VOLUME 2 OF 2 - ZONING

Z-000.00

# Summary of Comments on P:\Projects\1216-00\BIM\Revit

## \Families\TITLEBLOCKS\EXTELL Proposal\_atwalj.pdf

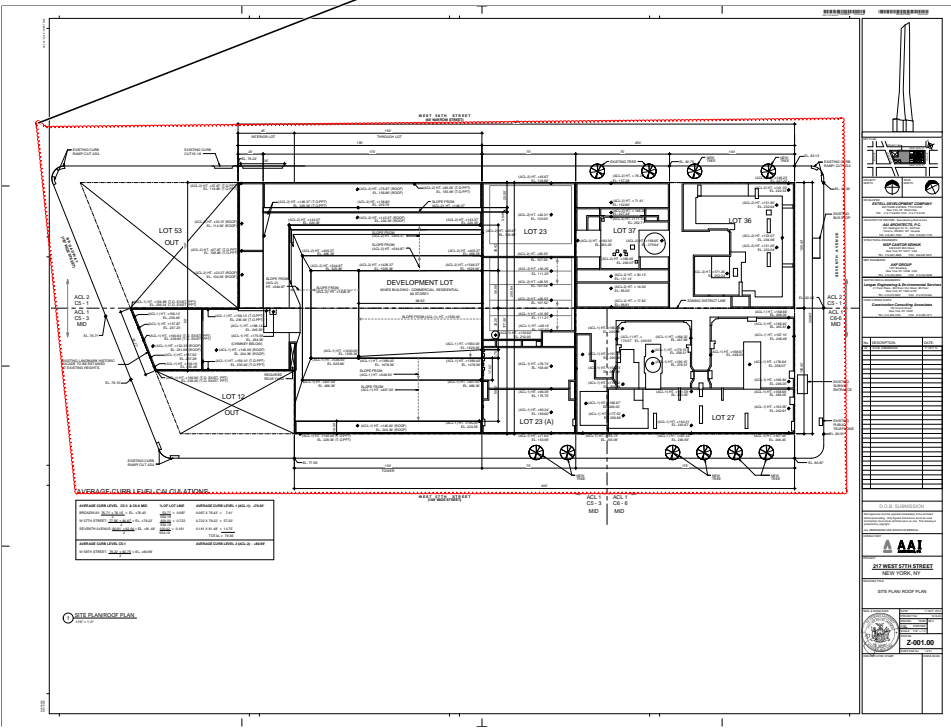
Verify compliance with street tree planting for the entire zoning lot street frontage as per ZR 33-03. Provide ST-1

Provide proper zoning exhibits for new enlargement as per memo 5/18/78. (CRFN # shall be located on the PW-1 item 9 and the Schedule "A" comment section)

Transit authority approval if required or provide note on plan "not within 200 feet of TA."

BC 3306 Provide Demolition application

TR-1 for soils – investigations(borings) rec/certif'd; TR-4 Boring report as per BC 1704

Submit a preliminary survey for verification of zoning lot metes and bounds, legal street elevation, street width, fire hydrant, tree location, and adjacent building heights etc.

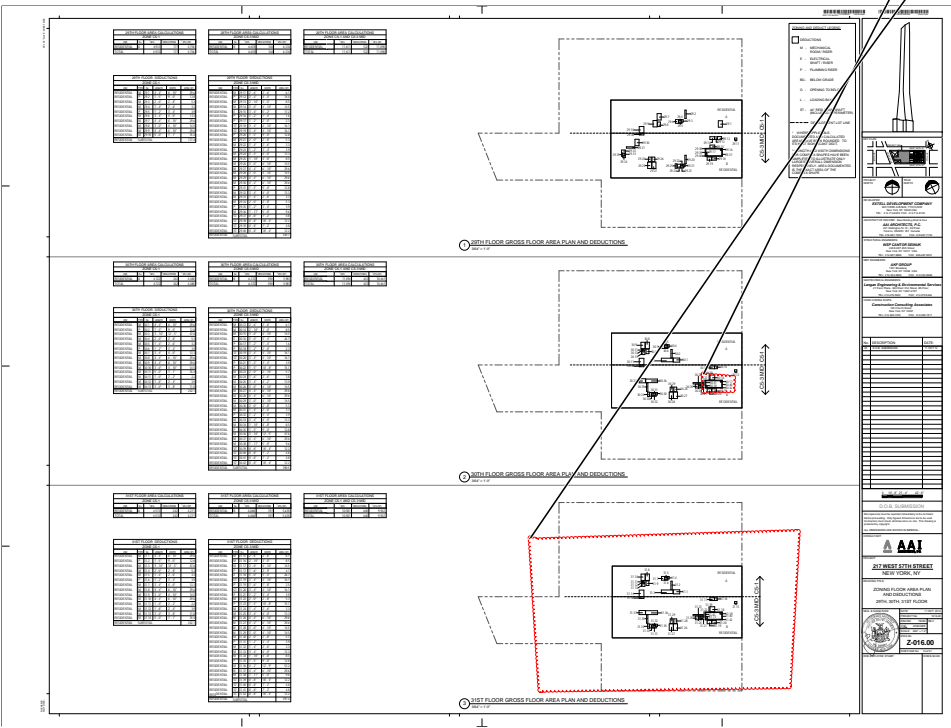
Author: dtitus Subject: Polygon Date: 1/8/2013 9:47:42 AM  
Please clarify deductions taken within stair inclosure. **TYP all floors.**  
8" for the stair perimeter, not sure what the additional 60+ sq. ft. is for per floor. ARCH/MH dwgs does not indicate any shaft enclosures within stair.

Author: dtitus Subject: Polygon Date: 1/8/2013 9:35:03 AM  
Mech. plan was not provided for this floor. 31st FL.

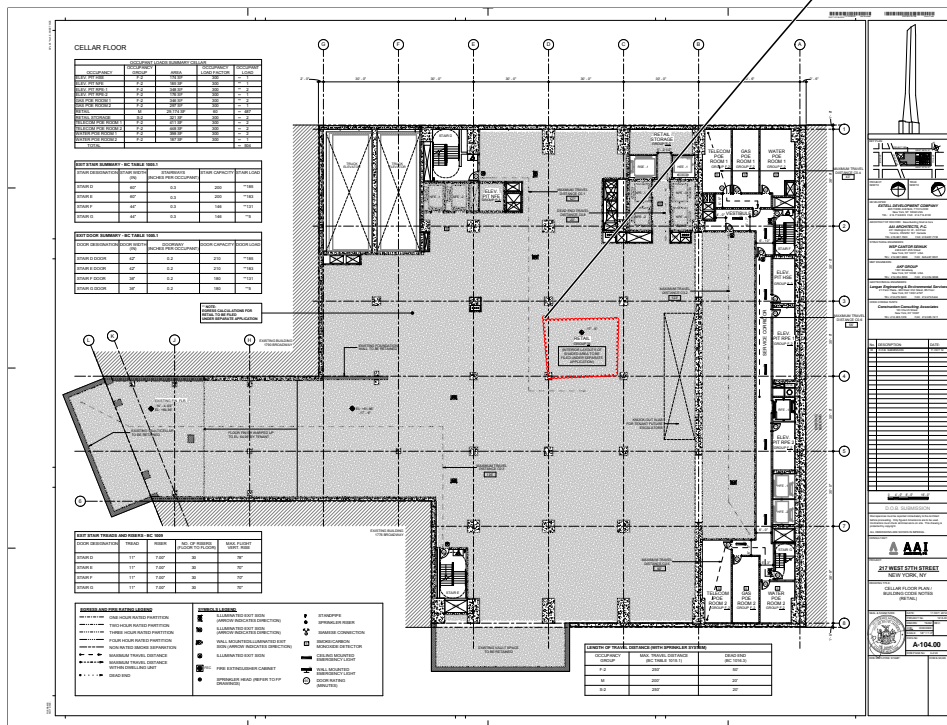
Author: dttus Subject: Polygon Date: 1/7/2013 10:14:55 AM  
TABLE 403.1 Provide table for plumbing fixtures to comply with table 403.1. Provide calculations within each space, etc. and show layout to verify compliance to BC 1101.2; ICC/ANSI A117.1-2003

All nonresidential facilities to comply with BC 1109.

Water closets

Lavatories

Show all grab-bars including vertical

Required clearance around the water closet to comply with ICC/ANSI 2003 604.3

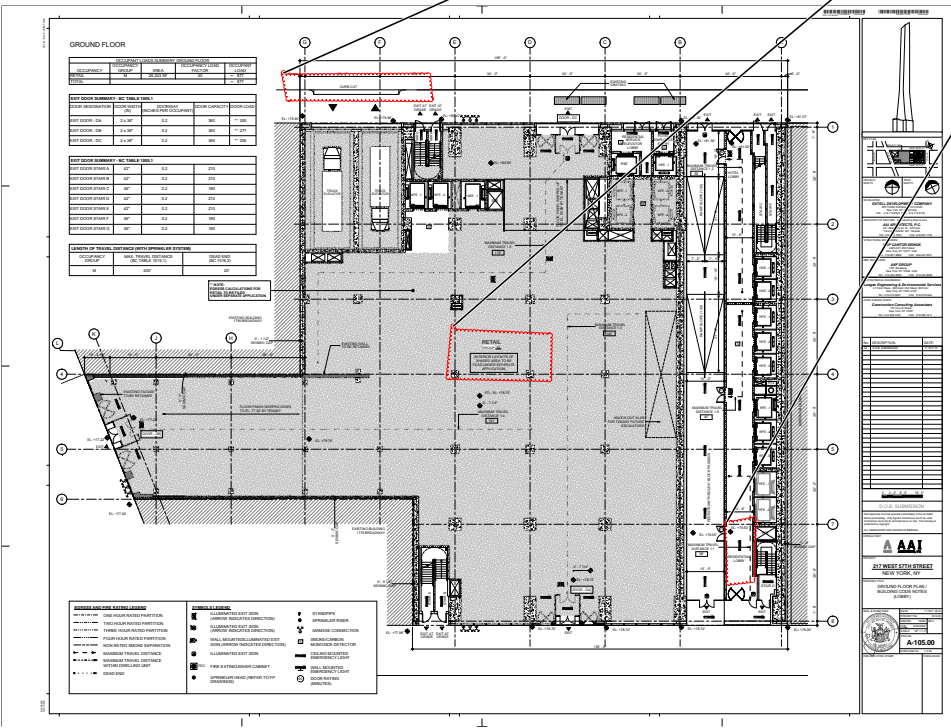
Author: dtitus Subject: Polygon Date: 1/2/2013 12:52:48 PM  
Provide curb cut details with plans and sections. **Filed under sep appl. 04-03-13**

Location of proposed curb cut is contrary to section BC 406.7.6 (3). This is not a corner lot and a minimum separation of 8'-0" is required from side lot line.

Author: dtitus Subject: Polygon Date: 1/7/2013 10:14:43 AM  
TABLE 403.1 Provide table for plumbing fixtures to comply with table 403.1. Provide calculations within each space, etc. and show layout to verify compliance to BC 1101.2; ICC/ANSI A117.1-2003 **04-03-13**

All nonresidential facilities to comply with BC 1109.  
Water closets  
Lavatories  
Show all grab-bars including vertical  
Required clearance around the water closet to comply with ICC/ANSI 2003 604.3 **04-03-13**

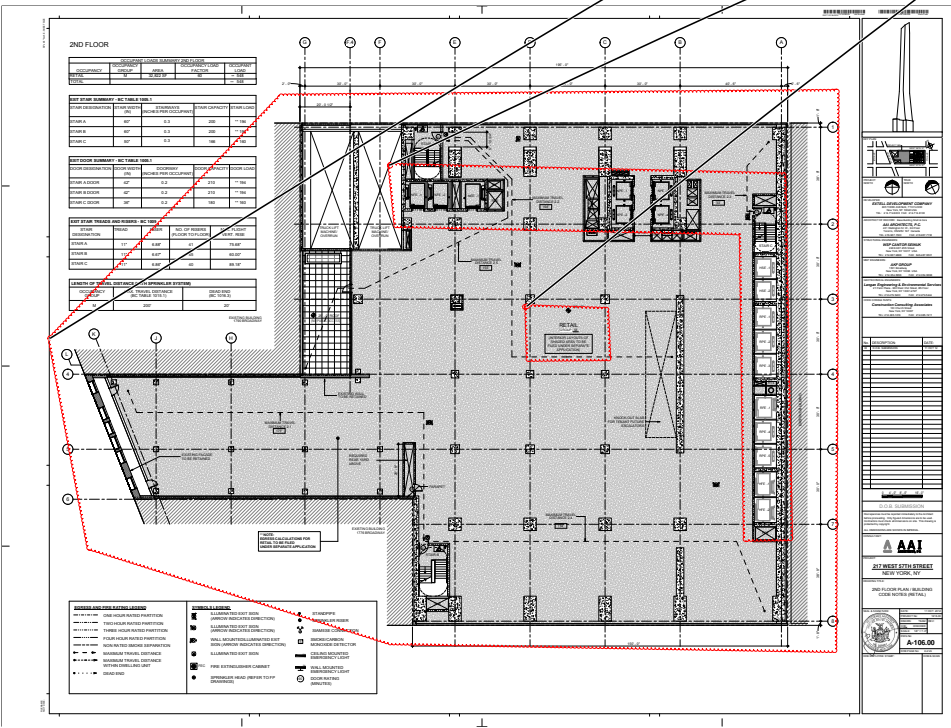
BC 1910, LL 17/95 **Earthquake**  
state on plan and show compliance with LL 17/95;  
separation (1" per 50 ft. height); (compliance must be verified on A & ST floor plans)  
earthquake code applicability & pounding notes;

Author: dtitus Subject: Polygon Date: 1/7/2013 9:28:30 AM  
Elevator to accommodate 24"x76" ambulance stretcher (BC 3002.4).

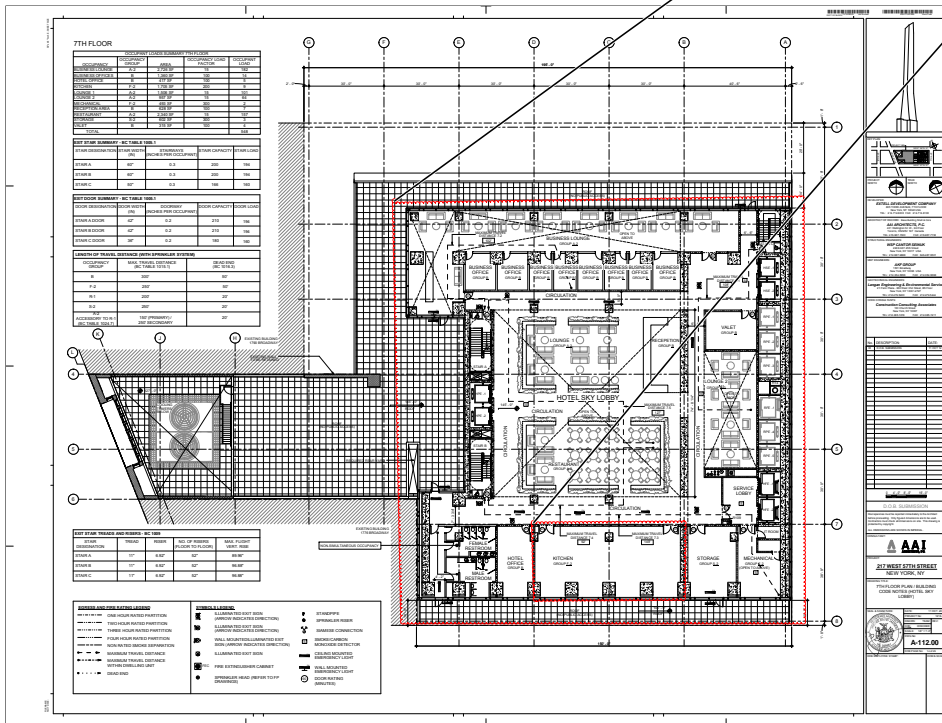
**BC 903.2.12.2 Commercial cooking operations.** An automatic sprinkler system shall not be installed in a commercial kitchen exhaust hood and duct system. Fire extinguishing systems shall be installed in commercial cooking systems in accordance with Section 904.11.

**BC 904.2.1 Hood system suppression.** Each required commercial kitchen exhaust hood and duct system required by the *New York City Fire Code* or the *New York City Mechanical Code* to have a Type I hood shall be protected with an approved automatic fire-extinguishing system installed in accordance with this code.

Kitchen shall also comply with MC 506, 507, and 508; PC 802.1.7 and 1003.3.1. Please verify on MH/PL plans.

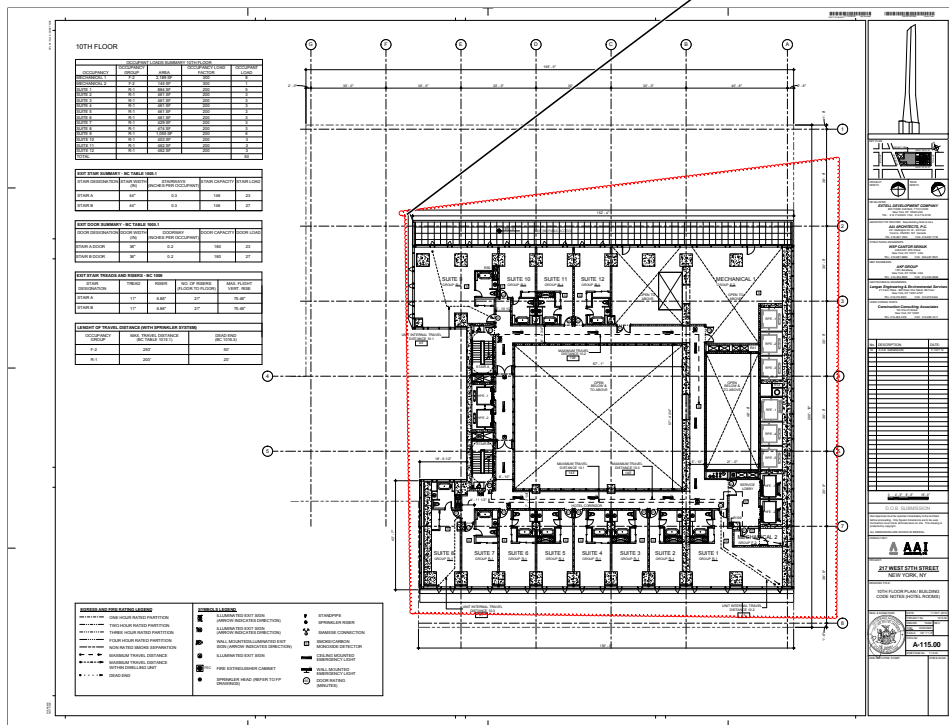
The common path of egress travel shall not exceed 125 feet as per BC 1013.3. The maximum length of exit access travel, measured from the most remote point within a story/space to the entrance to an exit along the natural and unobstructed path of egress travel, shall not exceed the distances given in BC Table 1015.1.

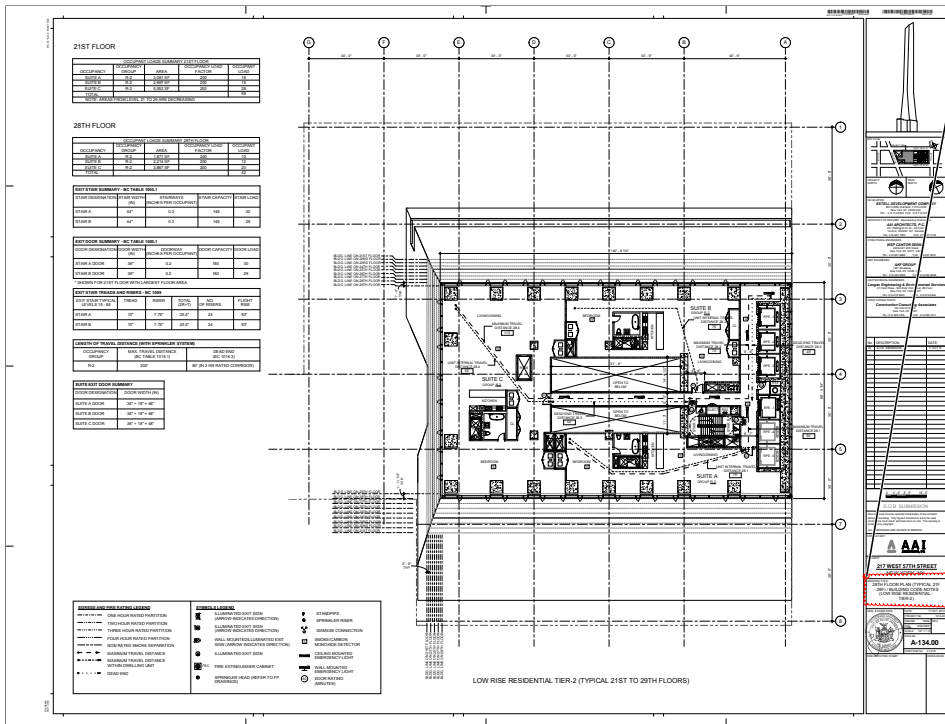
The common path of egress travel shall not exceed 125 feet as per BC 1013.3. The maximum length of exit access travel, measured from the most remote point within a story/space to the entrance to an exit along the natural and unobstructed path of egress travel, shall not exceed the distances given in BC Table 1015.1.

BC 908.7.1.2 Provide notes to indicate compliance for carbon monoxide detectors.

Indicate location of smoke/ carbon monoxide detectors. (TYP.)

Provide refuse chute details: [2 hr fr walls & roof] and compliance with BC 1213.3 and BC 707.13

Refuse storage room to comply with BC 1213.1

Provide proper enclosure and details

Provide UL # for system or fire hopper doors

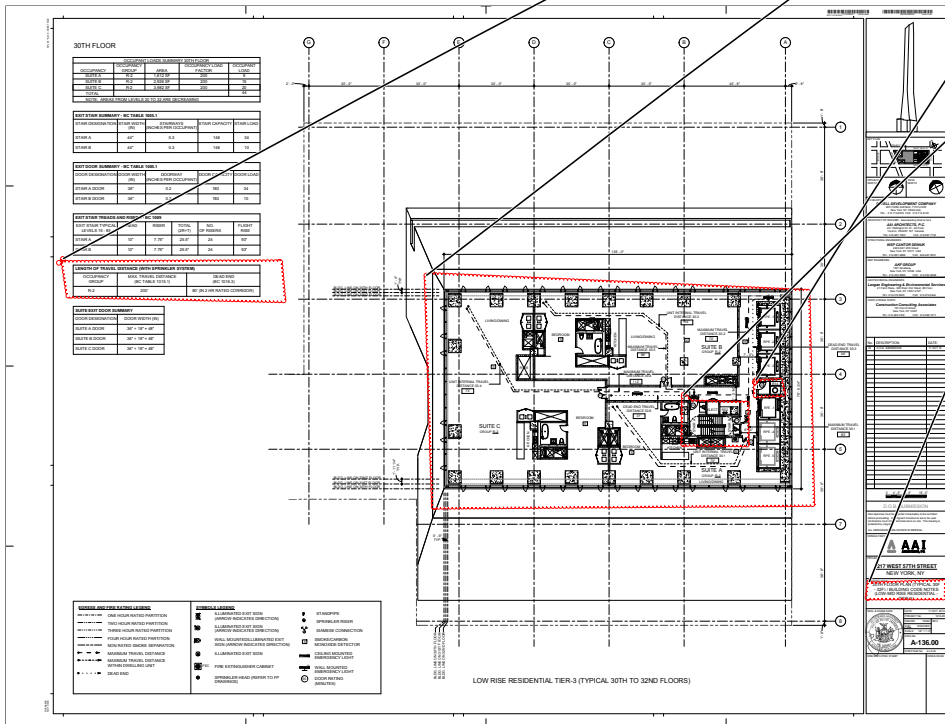
Provide note describing smoke proof exit enclosures for compliance with BC 403.13.

Provide note describing impact-resistant stairs enclosures as per BC 403.15

Provide exit lighting and directional signs (lighting) & (egress) as per BC 1006, BC 1011, BC 1026 (both EG and Construction plans)

Please indicate as Typ. 30-32nd Floor Plans

BC 1101.1, 1101.2, and  
ICC/ANSI A117.1-2003 Verify compliance with accessibility as per BC 1101  
Primary access- 1105  
Doors & maneuvering clearances-1107.2.1  
Residential bathrooms – 1107/ Appendix P  
Residential kitchens – 1107.  
Show all grab-bars including vertical as per P102.8.3.1,  
Walk-in closets  
Access to W/D within units  
**TYP. all R-2 floors**

Summary of Comments on FP-401.00

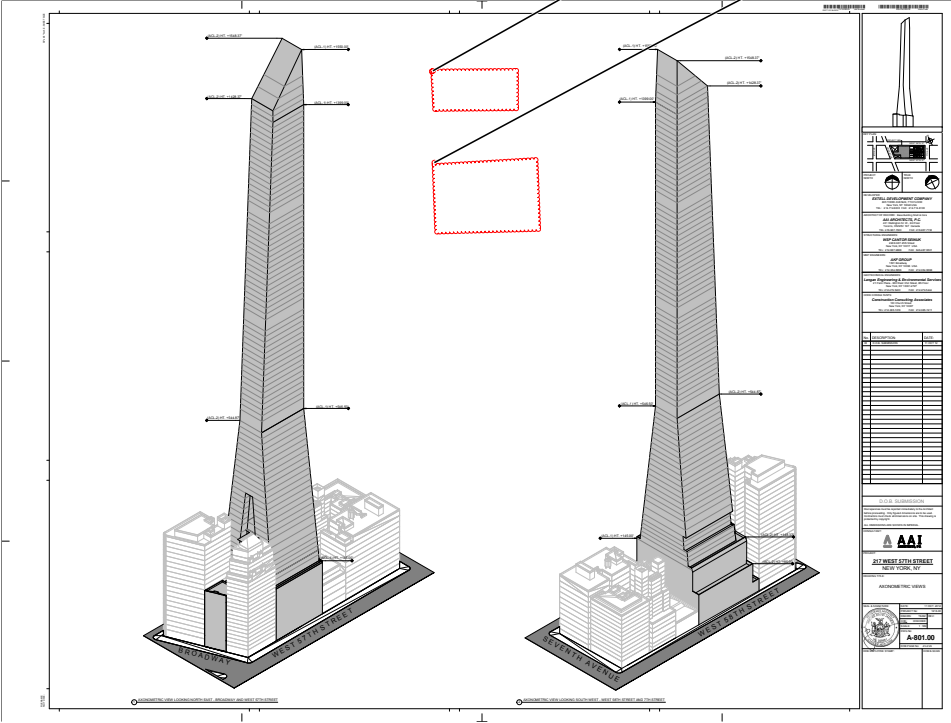
Provide building elements, exterior walls of non-combustible construction with fire-resistance ratings for Type I-B construction (BC 602.1, BC 602.2).

Author: dtitus Subject: Polygon Date: 1/8/2013 9:12:55 AM  
Please provide a complete water and gas riser diagram.
